Date: September 30<sup>th</sup>, 2025

Project Description: Fairview Village Affordable Housing Development

**Project/File:** **Fairview Village Affordable Housing Development / BOI25-0186 / DRH25-00226**  
This is a design review application to allow for the development of 205 affordable, multi-family residential units on 1.94-acres.

**Lead Agency:** City of Boise

OVERALL SITE PLAN

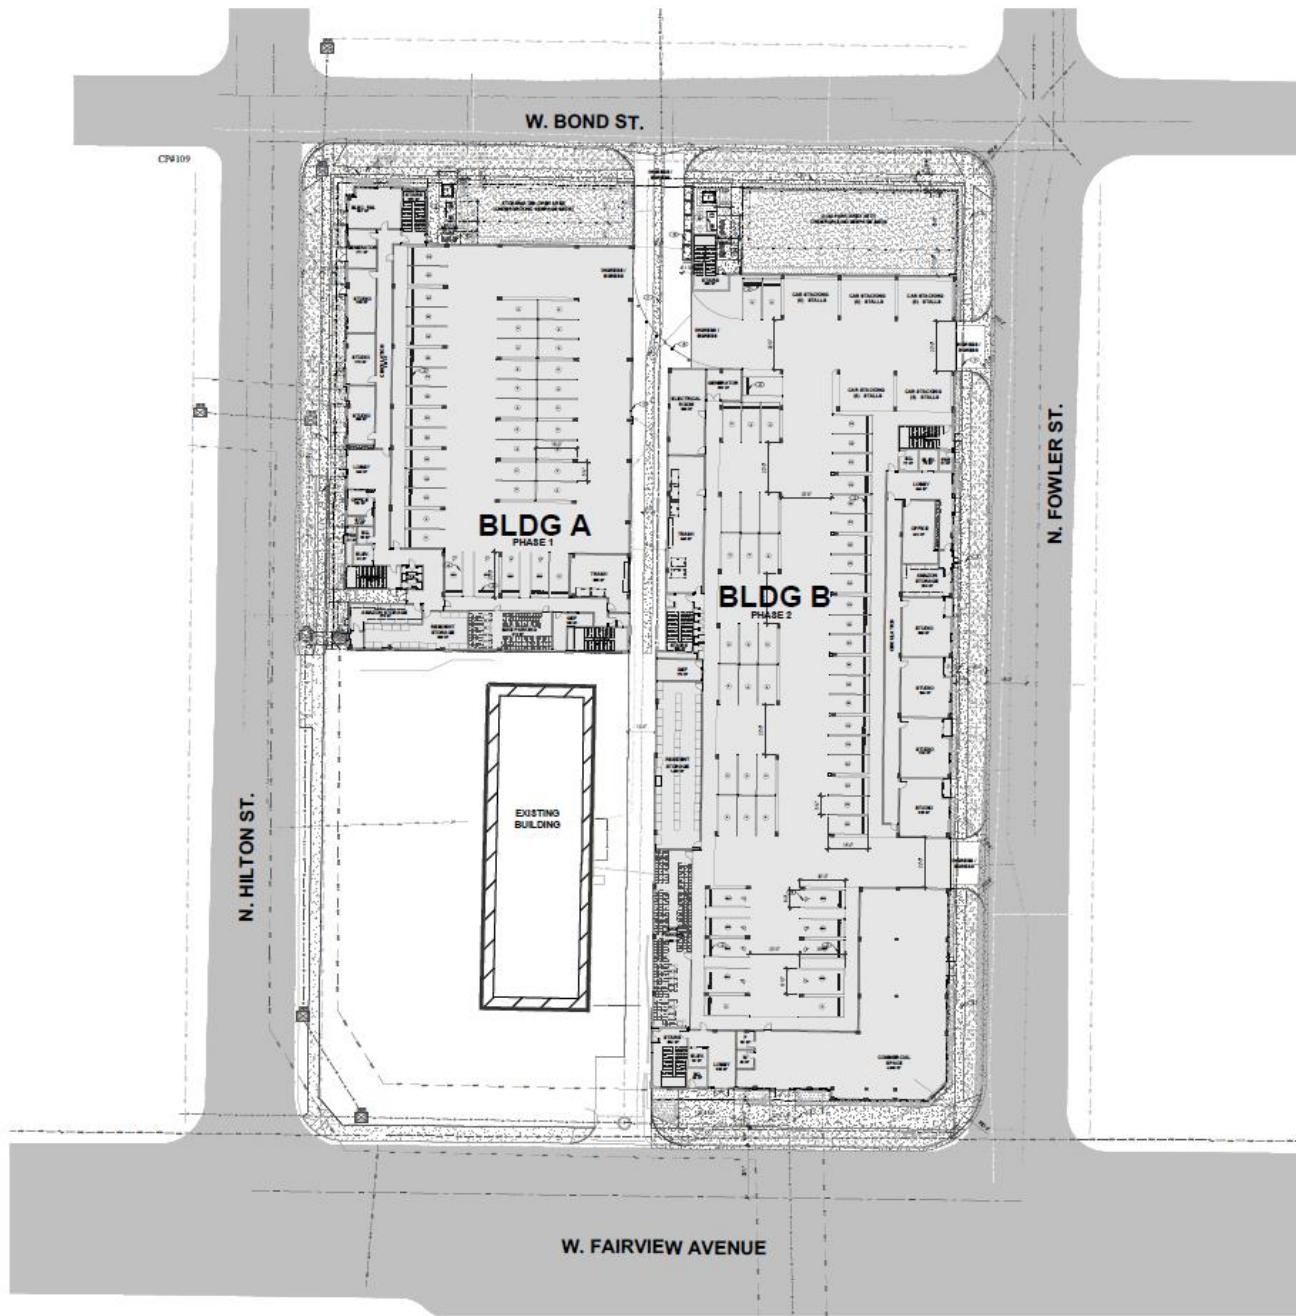
Typically, the applicant should be required to pave the alley from the nearest public street to and abutting the development. However, the alley right-of-way is unopened and unmaintained and due to the existing landscape improvements located within the alley south of and adjacent to the site..

The applicant's proposal to incorporate the alley right-of-way into their site does not meet District policy as it is public right-of-way under the jurisdiction of ACHD and should not be approved, as proposed. The applicant has the option to apply to vacate the alley right-of-way. If the right-of-way is to be vacated, then the applicant should apply to vacate the right-of-way by submitting an application to the Right-of-Way department prior to plan submittal. A right-of-way vacation is a separate application with its own public hearing process.

If the applicant chooses not to vacate the alley right-of-way, the applicant should be required to enter into a license agreement for any improvements within the right-of-way of the unopened/unmaintained alley.

No permanent structures should be constructed to preserve the right-of-way of the unopened/unmaintained alley.

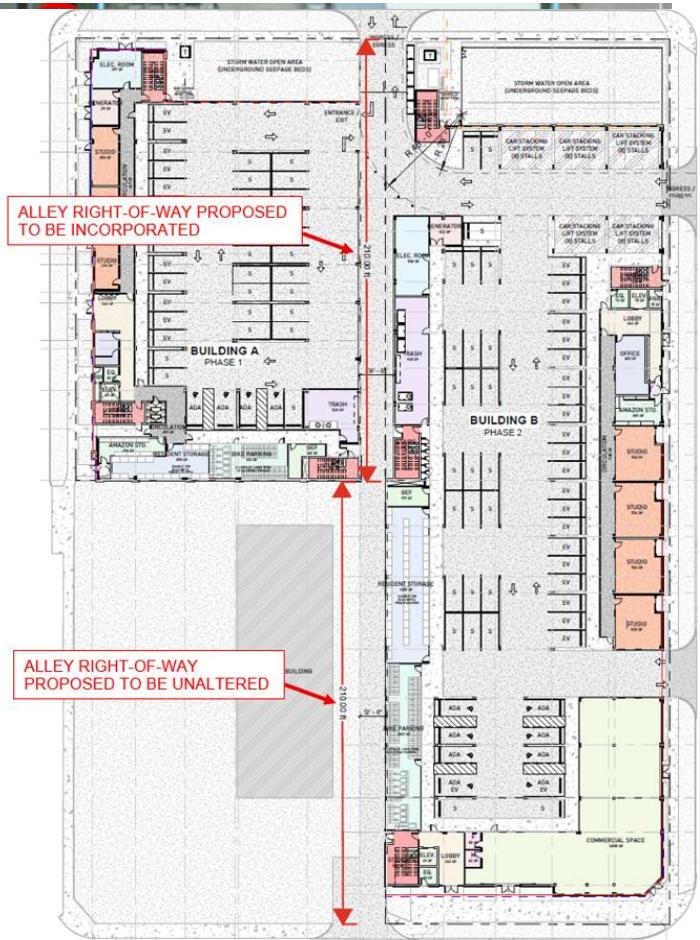
There are existing landscape improvements located within the alley right-of-way abutting the adjacent parcel located at the southwest corner of the site (circled below in red) that is not a part of this development (parcel no. R1625500855), preventing access to the alley right-of-way from Fairview Avenue.

**b. Applicant Proposal:** The applicant is proposing to incorporate a portion of the unopened and unmaintained alley right-of-way into their site as a drive aisle. The applicant is not proposing any alterations to the southern 210-feet of alley right-of-way (as shown).
